This gallery shows some pictures of bad solderings - they should prevent you from making the same errors (feel free to add even more pictures here!)

Permanent link:  
[http://wiki.midibox.org/doku.php?id=bad\\_solderings\\_gallery](http://wiki.midibox.org/doku.php?id=bad_solderings_gallery)

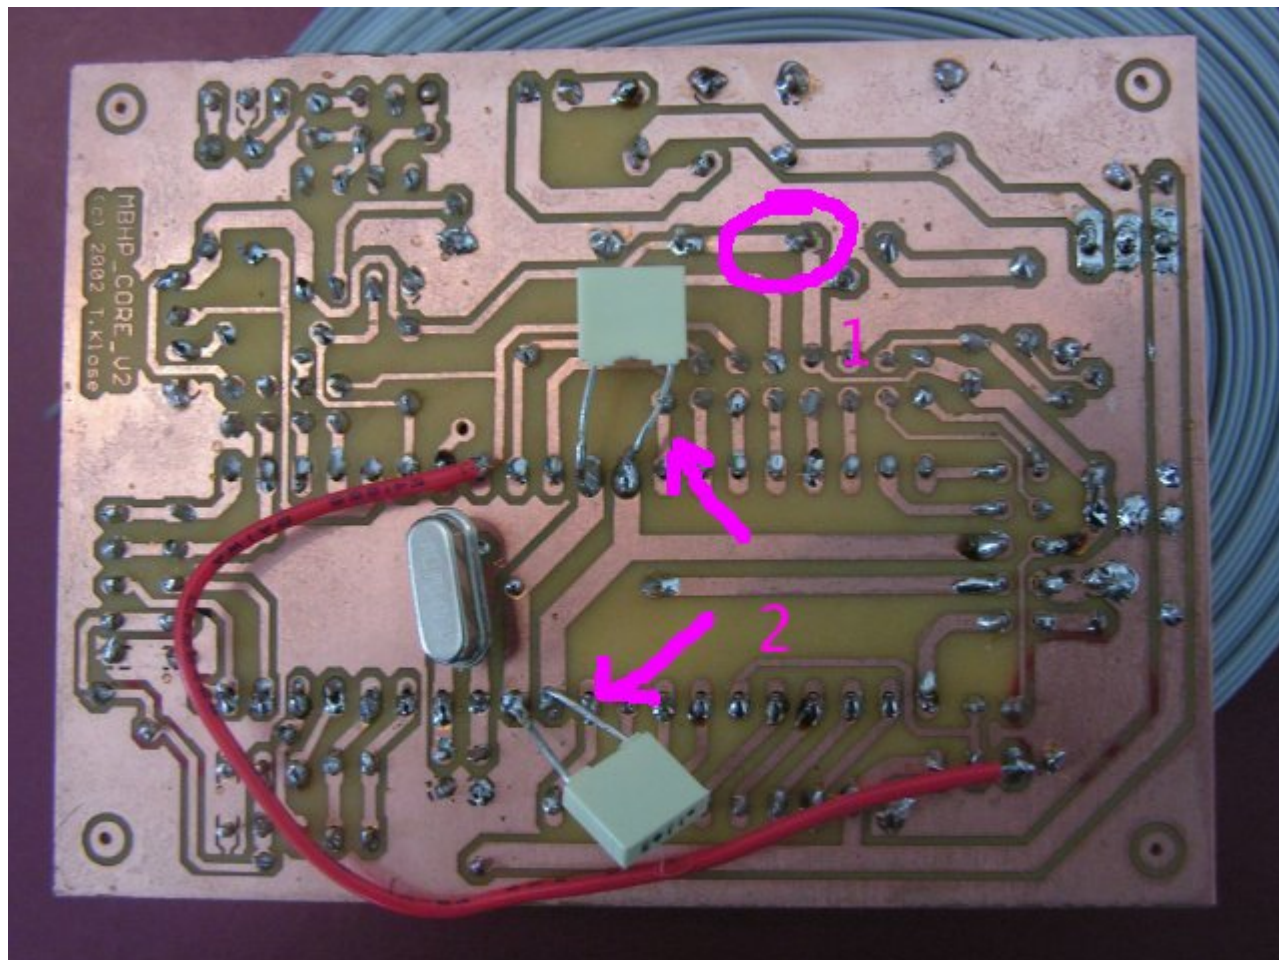
1: The core module has some badly soldered connections(loose), which could lead to failures. There are also missing solderings (e.g. 33pF cap below crystal). It makes sense to solder each pad again, the [Soldering](#) guide in the Wiki gives some useful tips

2: The legs of the caps should be cut, otherwise they can cause a short circuit which can damage the PIC!

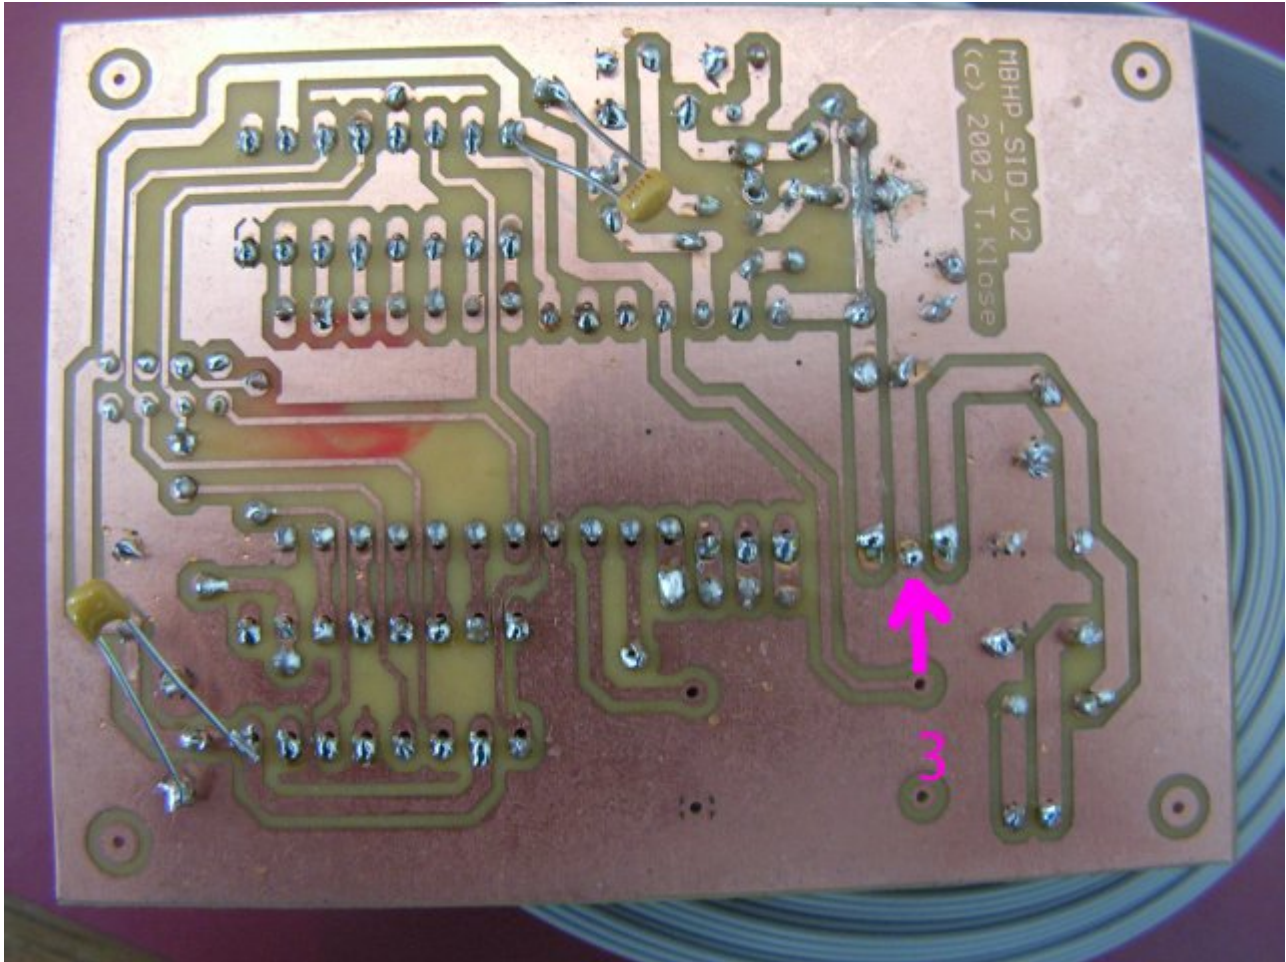
3: This seems to be a bad ground connection directly at the 78xx - it can lead to the wrong voltage. Here the same: just solder the pads again, it will help  
And same as above: the long cap legs need to be cut, the danger of shorting out is too high!
